PLANNING COMMISSION AGENDA

Tuesday, November 17, 2015
Breckenridge Council Chambers
150 Ski Hill Road

Planning Commission Staff Report

Proposal: To restore portions of the historic Marvel House (remove some non-compliant additions and restore the remaining portions), add a full basement with a separate living unit, connect a new residence to the back of the historic house and build a new separate garage (with an accessory apartment above) along the alley and to seek local landmark designation from the Town Council. The property will be re-subdivided under a separate application.

Master Plan,
Site Plan
Scale: 1/4" = 1'-0"
Date: 11-11-2015

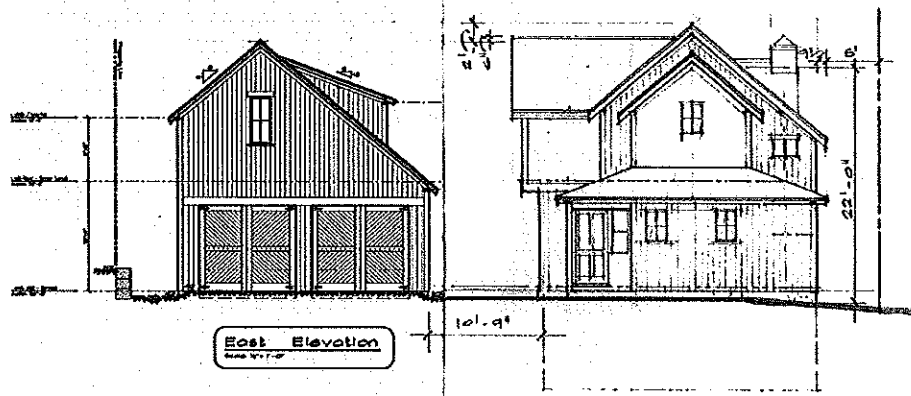
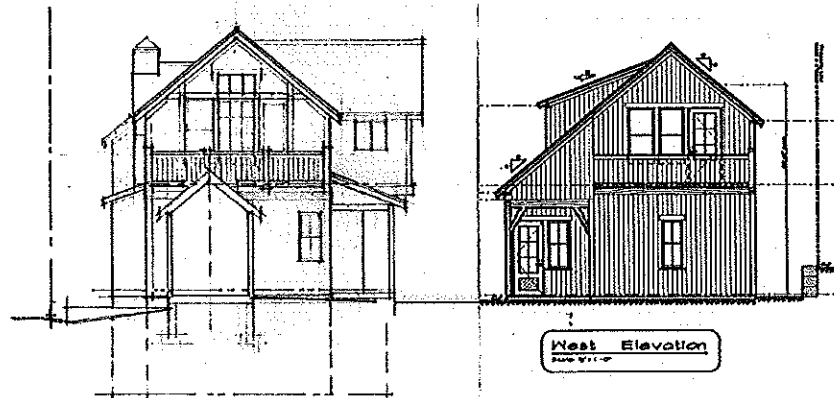
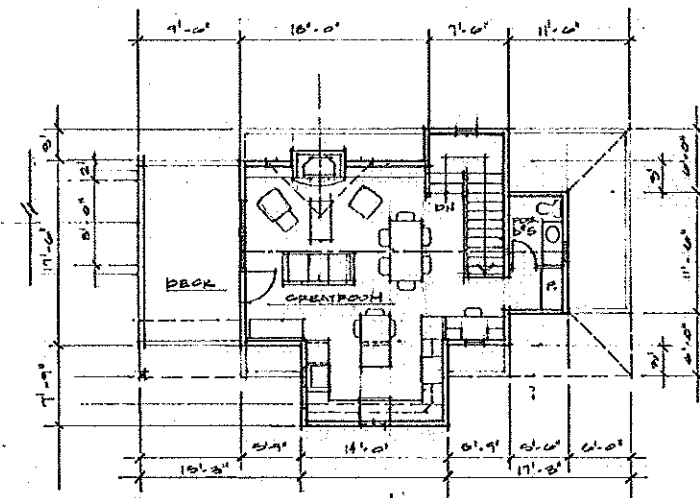
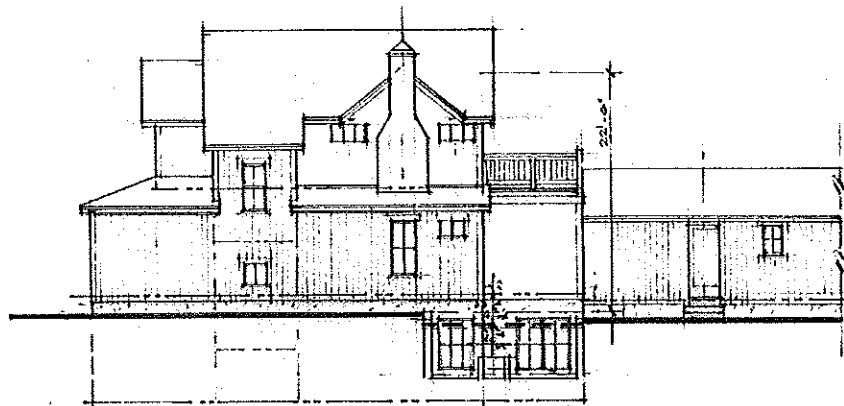
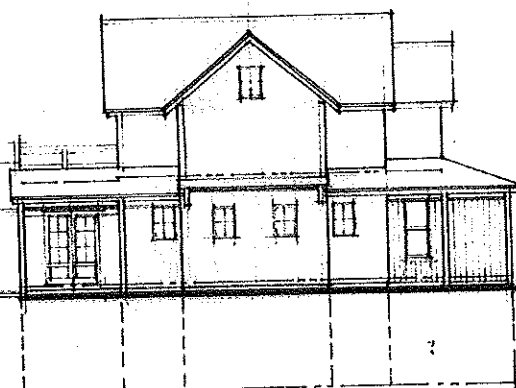
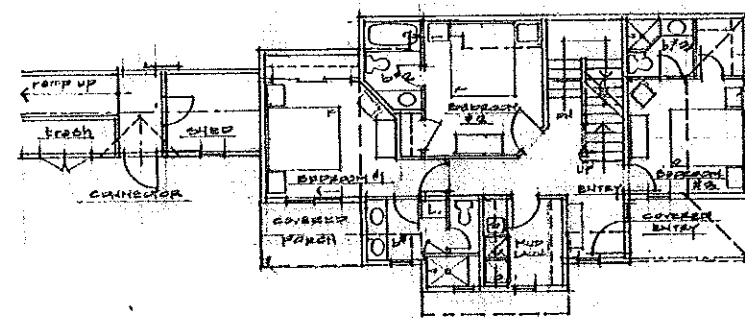
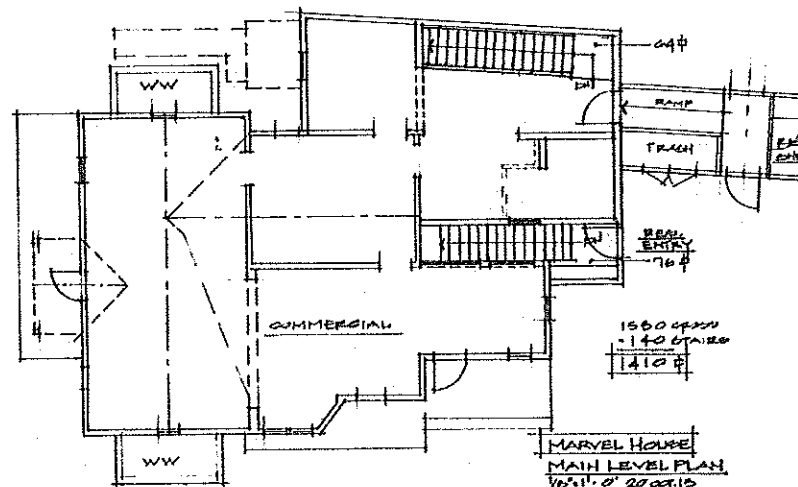
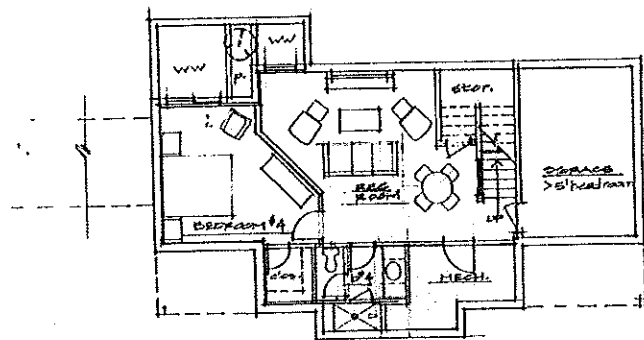
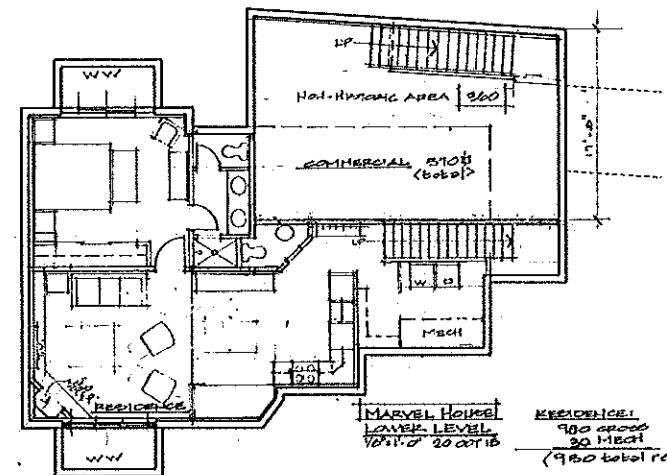
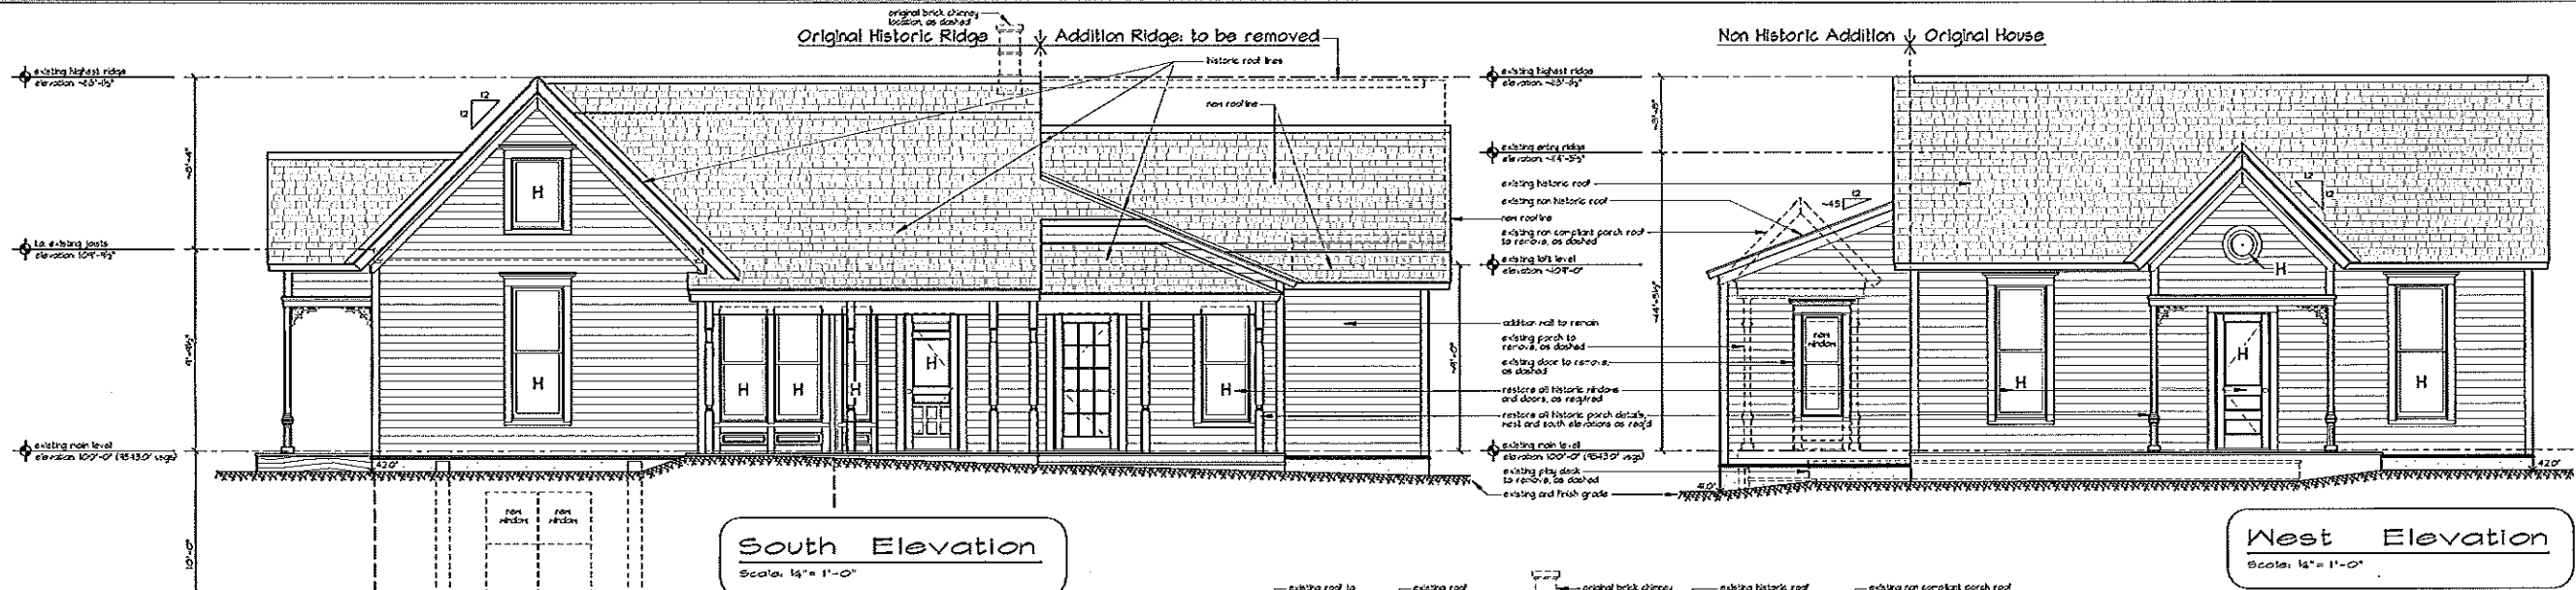
The revised plans show a shorter (18-foot) long connector than what was presented previously (30-foot). Staff heard some Commission support during the last meeting that the connector length should not be the cumulative addition of the height difference between building plus one half the historic building length. This would have resulted in a minimum 37-foot long connector for this property. Per Priority Policy 80A:

The plans show that the height of the one-story connector is clearly lower than either structure. The edges step in at least 2-feet (2 to 10-feet). The proposed form is a simple gable with a door, barn doors for trash, and a window. The length of the connector separates the historic structure front the new by 18-feet. Staff believes the design meets the intent of Policy 80A by clearly separating the massing modules with a subordinate form and design. Does the Commission concur?

Per the Development Code the suggested building height in this Character Area is 23-feet measured to the mean. The height of the New House is 23-feet meeting this policy. Heights along this Character Area vary from single story to over 3-stories for non-conforming structures. We believe the range of conforming building heights of historic buildings and supporting buildings should be used - 1 to 1-1/2 stories. Since the larger mass of the New House is at the back of the lot, preserving the character of the Marvel House, we believe the 23-foot tall addition meets the intent of this policy. Does the Commission Concur?

Since the last review, the drawings show that the façade of the New House facing the alley has been changed. An upper space has been eliminated reducing the building massing and allowing the roof forms to step down along this edge.

The drawings now show that the Marvel House will be moved 10-feet west and 3-feet south (enough to meet the suggested relative setback of 5-feet). As a result of the move, negative ten (-10) points will be incurred at final review.

1. Does the Commission support the length and design of the revised connector?
2. With the density and mass reduction and the stepped roof form off the alley, does the Commission believe the height of the New House meets the intent of Priority Policy 81 (Build to heights that are similar to those found historically) and Policy 82 (The back side of the building may be taller than the established norm if the change in scale will not be perceived from major public view points)?
3. Does the Commission believe the additions are similar in mass with the historic character area context?
4. Does the Commission support the proposed architecture?
5. Does the Commission support the landscaping plan as presented for positive two (+2) points?
6. Does the Commission support locally landmarking the historic Marvel House?
7. Does the Commission support the proposed point analysis?

Landscape Plan
Scale: 1/8" = 1'-0"
Date: 11-13-2015

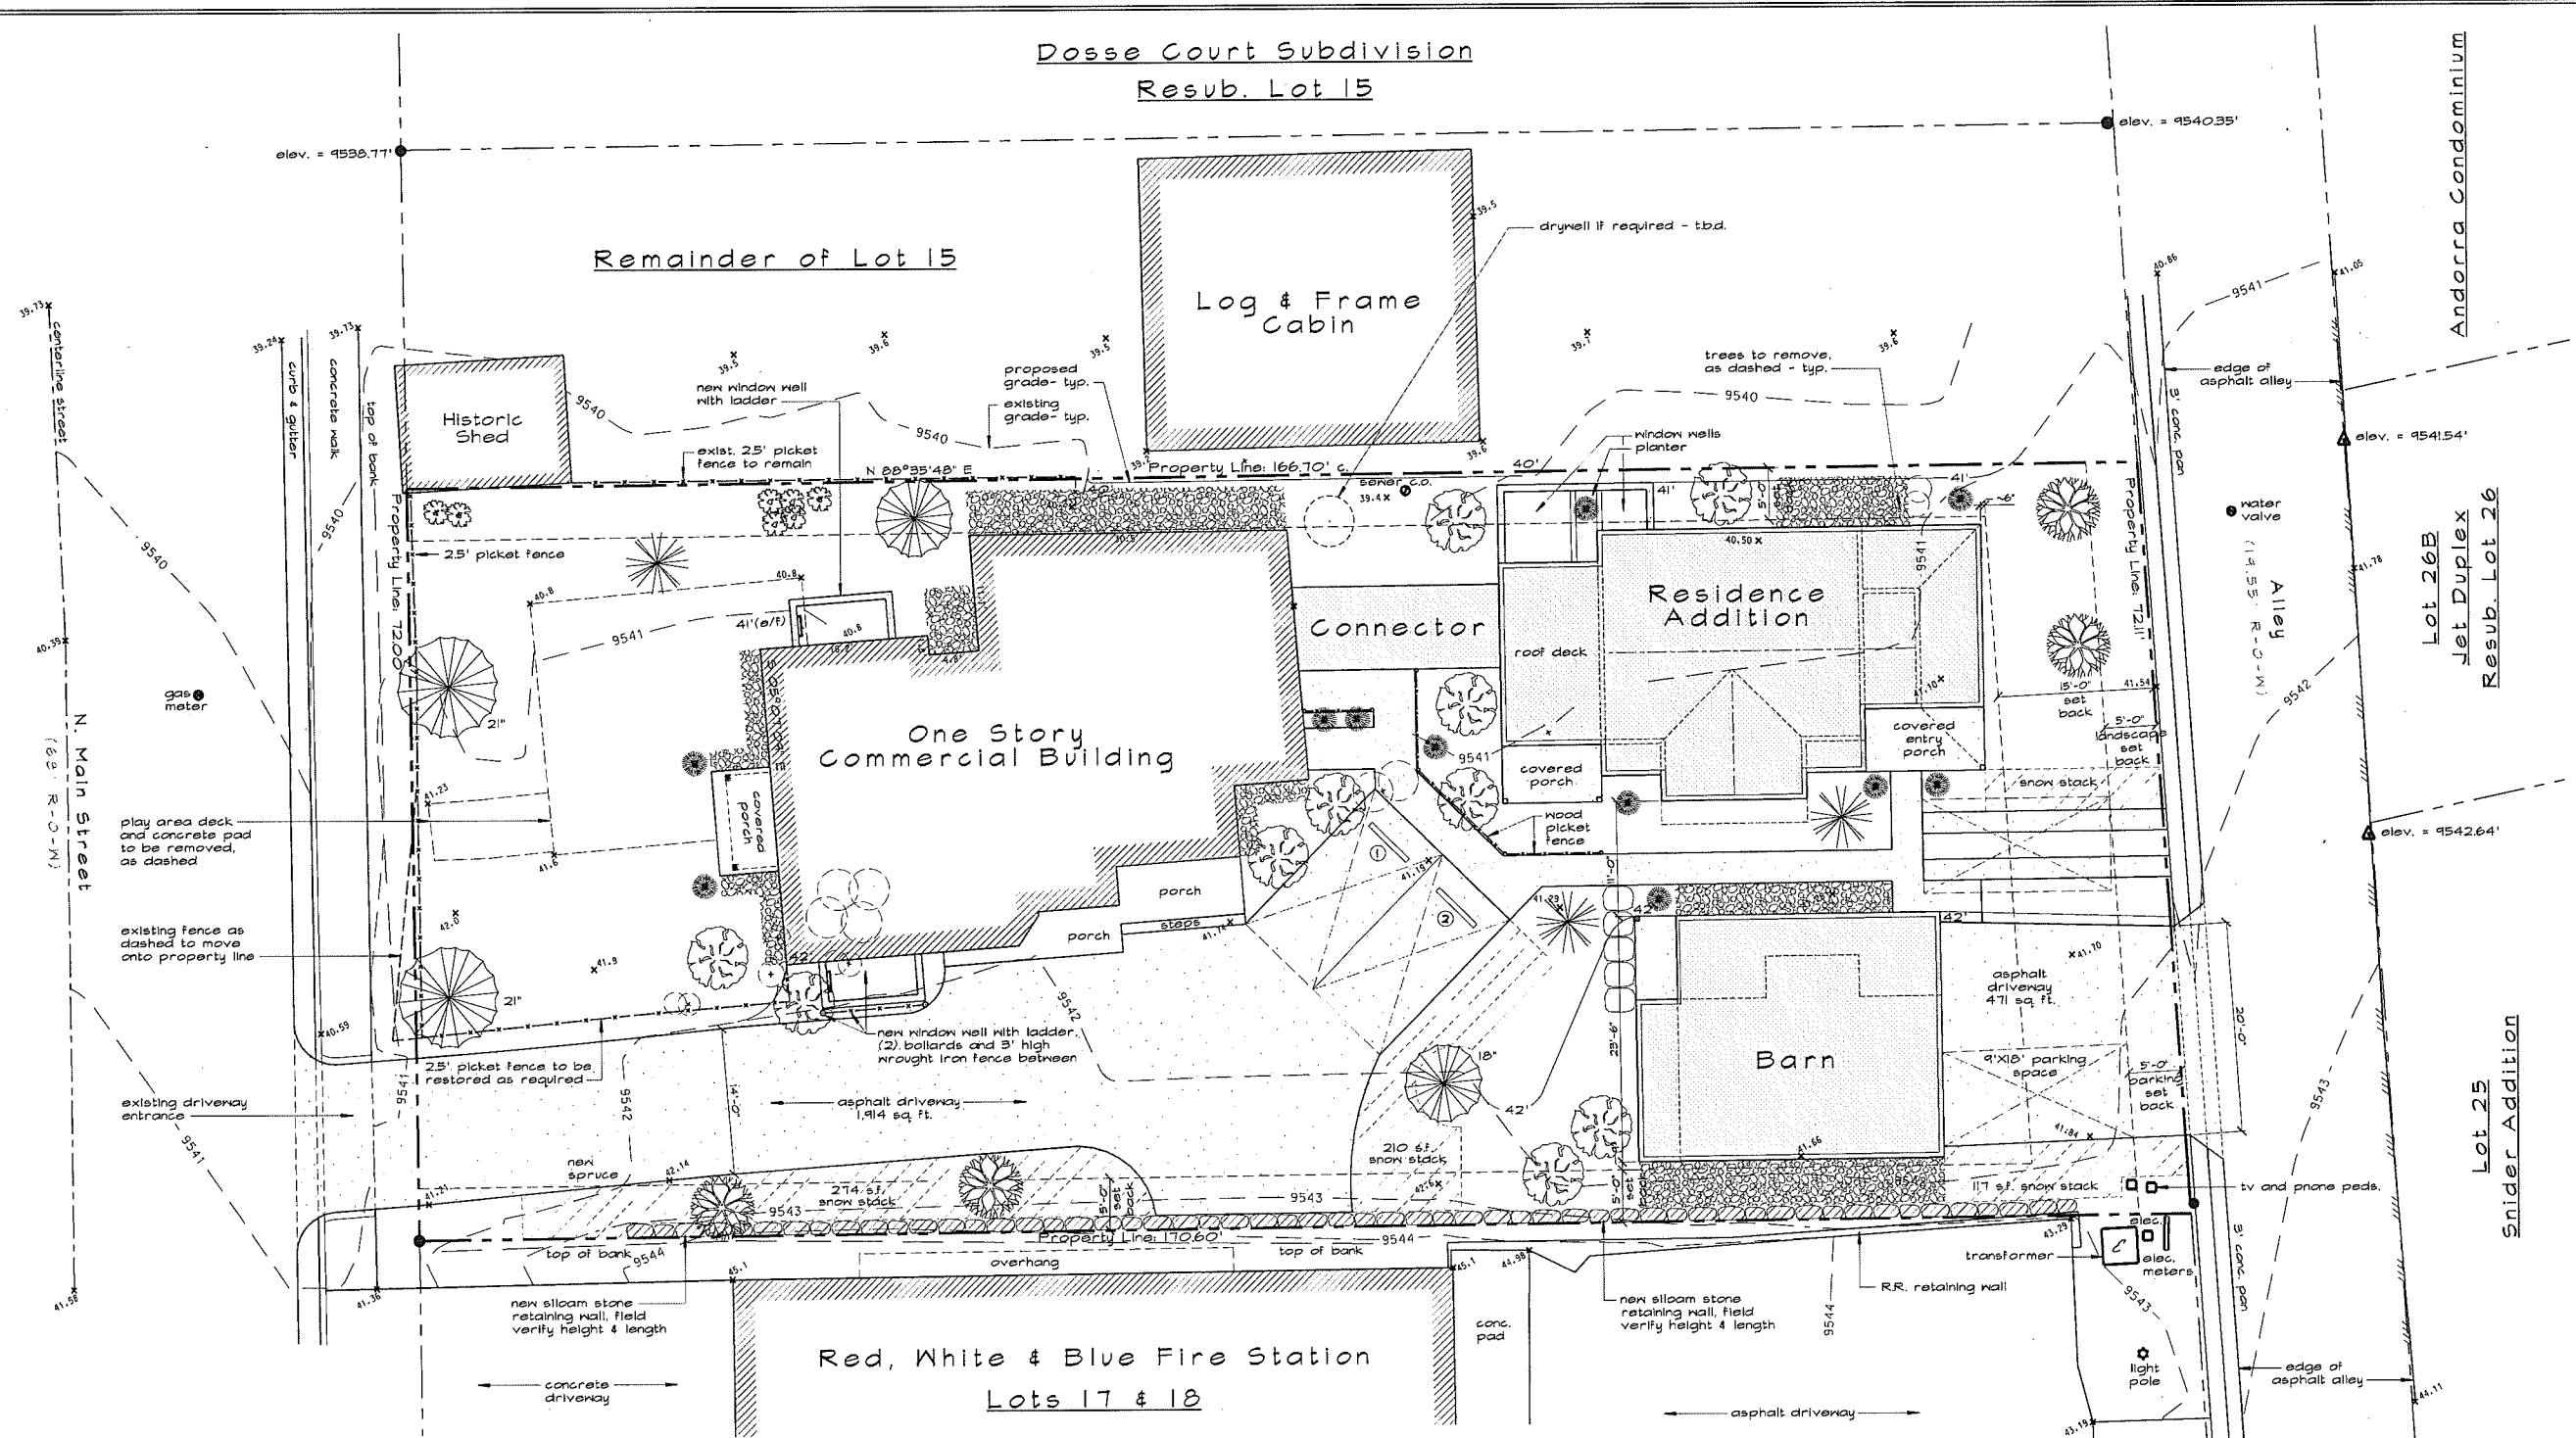
The proposed sizes show that 50% of the spruce and aspen meet suggested positive two (+2) point minimum and the other 50% are larger. But, the quantities are less than past precedent shows. Staff is suggesting the quantities be increased to meet the positive two (+2) point threshold. The applicant is seeking Commissioner input.
